ADDENDUM #1

RFQ No. 22-076-3320

For: Geotech Services for Church Rd. and Martin Rd. Gravity Sewer

Attachment 1 Boring Locations:

ATTACHMENT A
Boring Locations

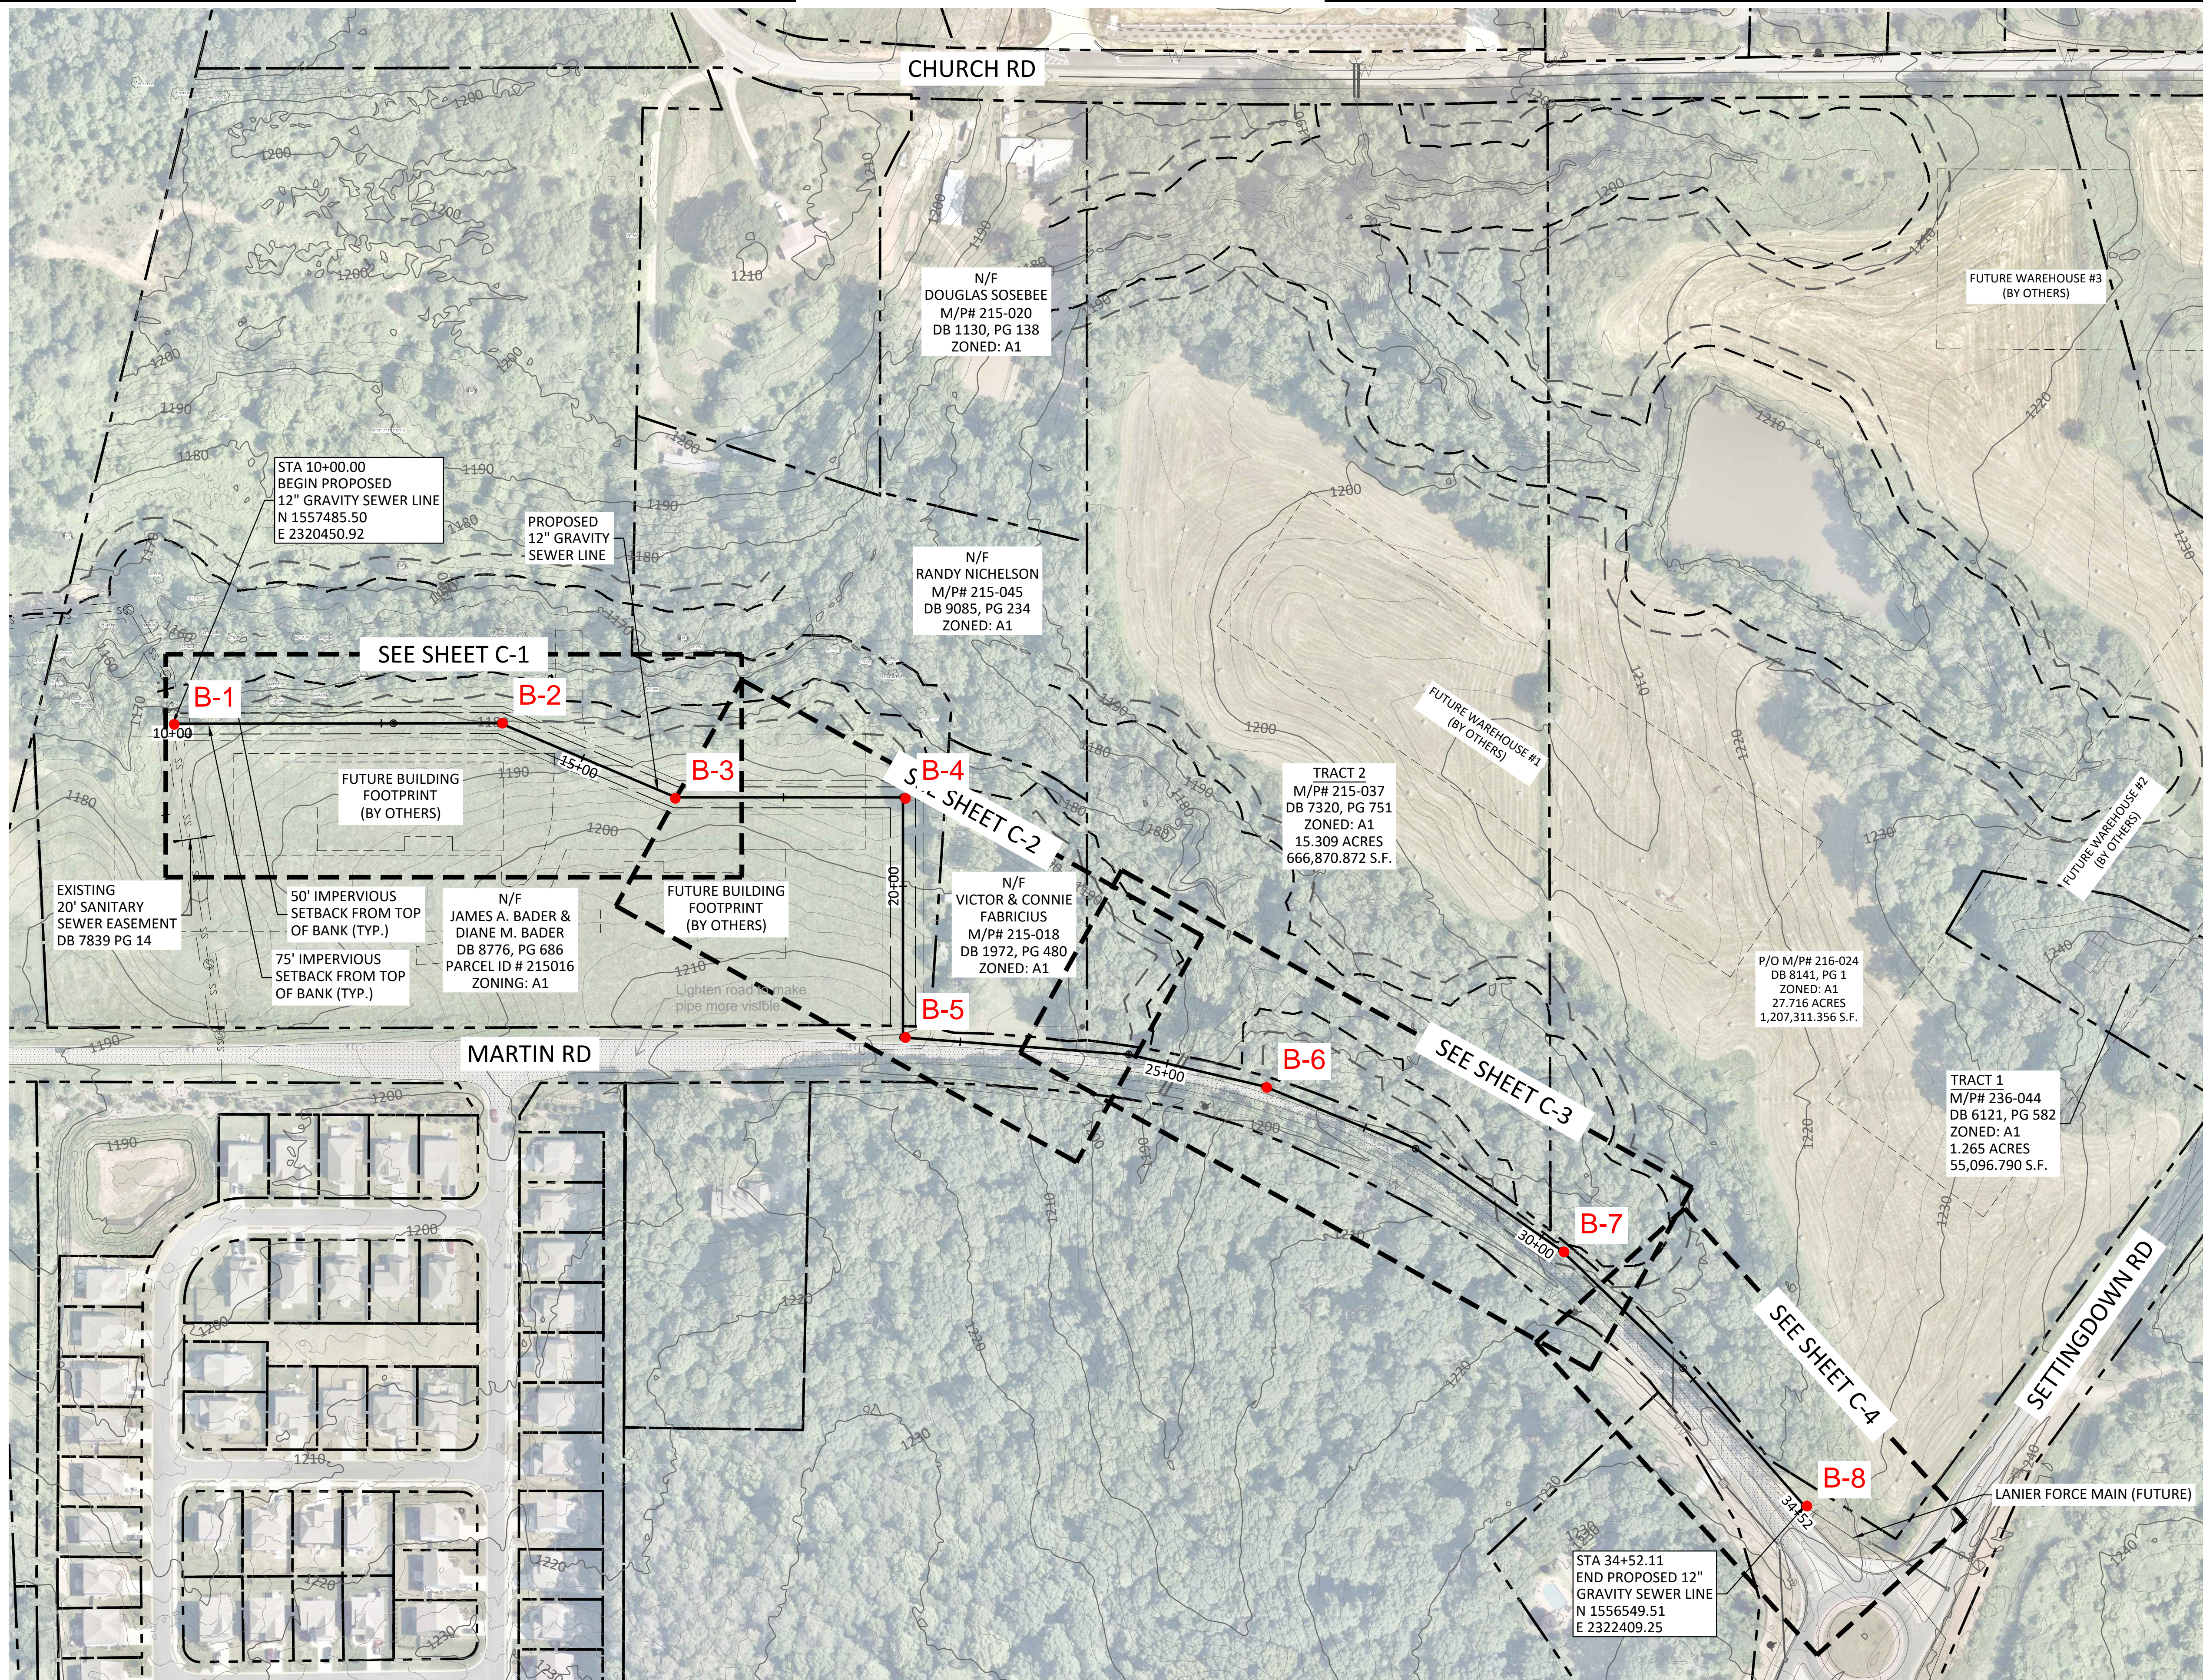
Boring Number	Location	Approx. Existing Grade Elevation	Remarks	Boring Depth
B-1	MH01 STA 10+00	1174	Doghouse Manhole #1	20 ft
B-2	MH03 STA 13+92	1180	Manhole #3	15 ft
B-3	MH04 STA 16+21	1197	Manhole #4	25 ft
B-4	MH05 STA 18+93	1192	Manhole #5	10 ft
B-5	MH06 STA 21+81	1210	Manhole #6	25 ft
B-6	MH08 STA 26+20	1196	Manhole #8	10 ft
B-7	MH10 STA 30+30	1209	Manhole #10	15 ft
B-8	MH012 STA 34+52	1226	Manhole #12	10 ft
